SAFETY EVALUATION OF THE SEABROOK NUCLEAR POWER STATION UNITS NOS. 1 & 2

**DOCKET NOS. 50-443
50-444**

**U. S. ATOMIC ENERGY COMMISSION
DIRECTORATE OF LICENSING
WASHINGTON, D. C.**

17.0 QUALITY ASSURANCE

FIGURE 17-1
PSM1 - YAEC ORGANIZATION INTERFACE

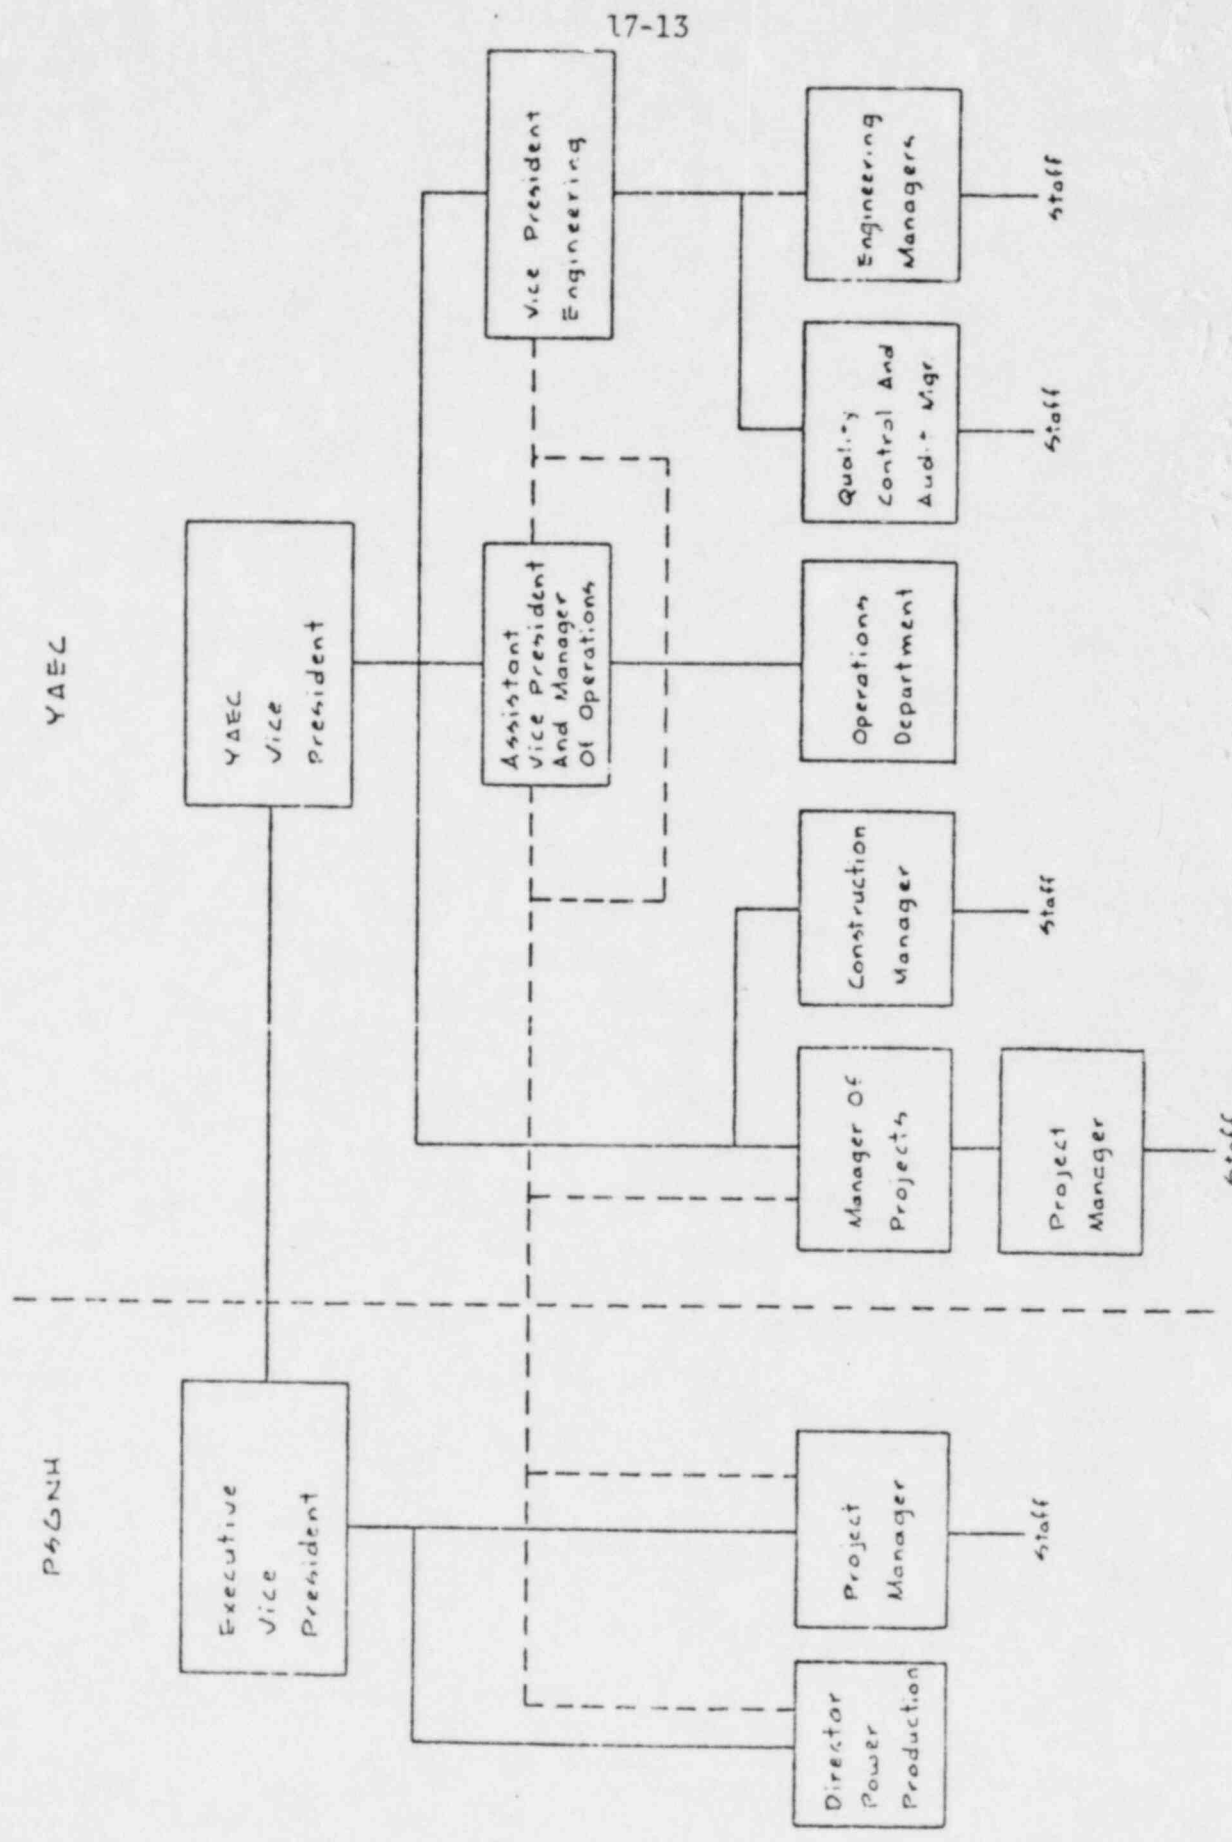
The PSNH project manager does not have assigned QA responsibilities and, as shown on Figure 17-1, there is no organizational element within the PSNH organization to review, monitor and maintain cognizance of the quality assurance activities during the design and construction of the facility. The President and Executive Vice-President directly retain the responsibility for QA aspects by reviewing YAEC quarterly QA summaries, YAEC monthly summaries, results of YAEC audits of subcontractors and attending YAEC meetings. We are (1) evaluating the additional information submitted by the applicants in Amendment 21 and (2) considering the corporate interrelationships between PSNH and YAEC. The results of our review will be documented in a supplement to this report.
